FEDERAL ENERGY REGULATORY COMMISSION
WASHINGTON, D.C. 20426
May 31, 2018

Project No. 1889-085 – Massachusetts
Project No. 2485-071 – Massachusetts
FirstLight Hydro Generating Company

**Subject: Determination on Requests for Study Modifications – Turners Falls
Project and Northfield Mountain Pumped Storage Project, Study 3.3.3**

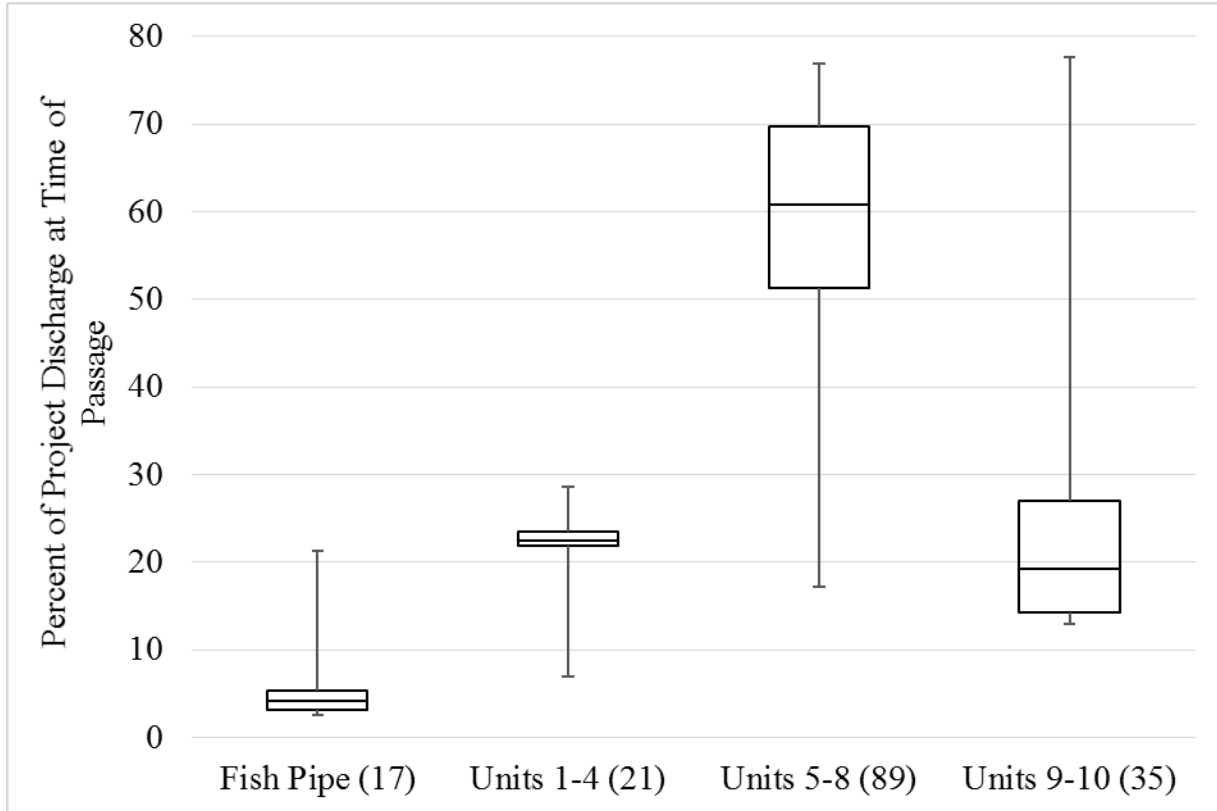
shad passing over the Turners Falls Dam versus through the power canal. In 2015, Great River Hydro, LLC released 310 radio-tagged juvenile shad upstream of the Vernon Project Dam. Route selection data is available for 170 of the individuals.¹⁵ Great River Hydro, LLC recorded discharge data for all available passage routes (*e.g.*, spillway, turbines, downstream passage facilities) at the time of passage for each tagged shad.¹⁶ Collectively, the operation and passage data suggest that the majority of the juvenile shad passed through the route with the greatest proportion of project discharge (Figures 1 and 2). The data from the Vernon Project is qualitatively consistent with the limited data provided by FirstLight's radio-tagging study at the Turners Falls Project. Specifically, 11 tagged shad reached the Turners Falls Project on October 12, 2015, and 10 passed into the power canal, which was passing approximately 60 to 68 percent of project discharge at the time of passage.¹⁷ Based on this information, it appears likely that juvenile shad route selection at the Turners Falls Project is predominantly influenced by the proportion of discharge through the available passage routes.

Figure 3. Connecticut DEEP Juvenile Alosine Seine Survey annual index of abundance for juvenile shad. The red dots indicate the index values for 1992 and 2015. (Source: Staff analysis of Appendix F of CRASC (2017).)

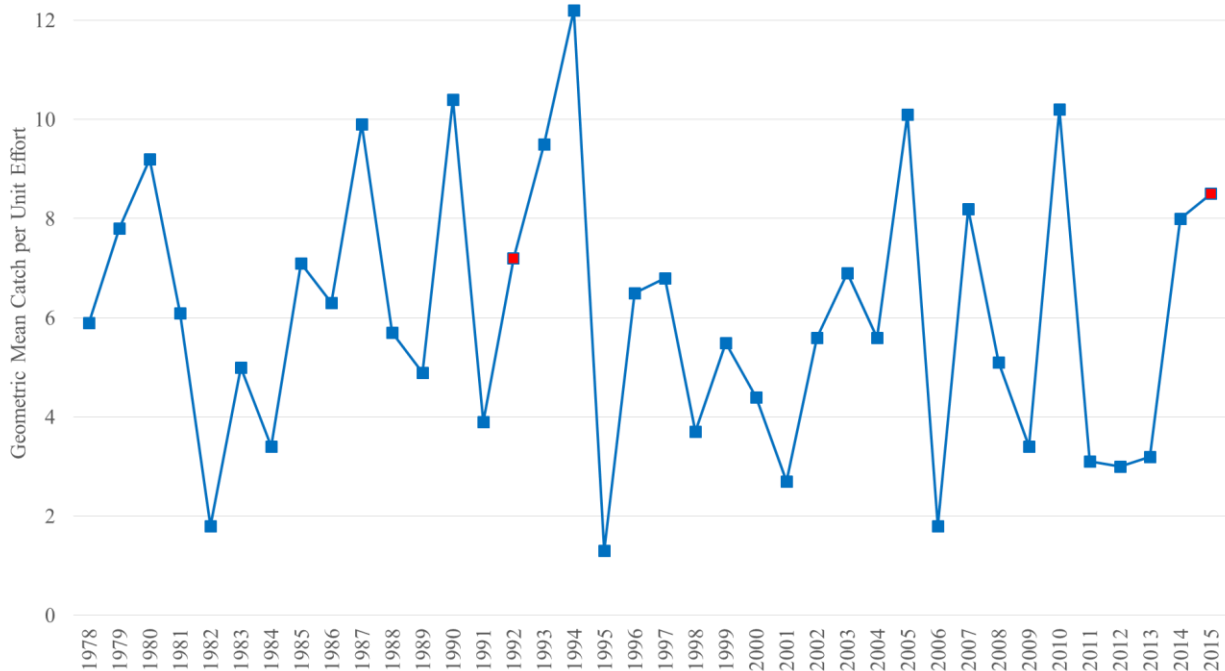
Regarding FWS’s concern about the number of juvenile shad available for entrainment in 1992 and 2015, data from the Connecticut Department of Energy and Environmental Protection’s (Connecticut DEEP) juvenile shad abundance index values for 1992 and 2015 indicates that abundance was relatively similar between the two study years (7.2 and 8.5, respectively) and is smaller than the differences observed between many consecutive years (e.g., 2010 and 2011; Figure 3).¹⁹ The similarity in abundance values between 1992 and 2015 suggest that the number of juvenile shad that could potentially be entrained at the Northfield Mountain Project was comparable in 1992 and 2015 despite the increases in capacity at the Vernon Project, the implementation of downstream passage measures at the Vernon Project, and the decommissioning of the Vermont Yankee nuclear power plant. Based on our assessment of the environmental conditions at the projects, the LMS (1993) study is likely sufficient for an analysis of the rate of juvenile shad entrainment at the Northfield Mountain Project during downstream migration.
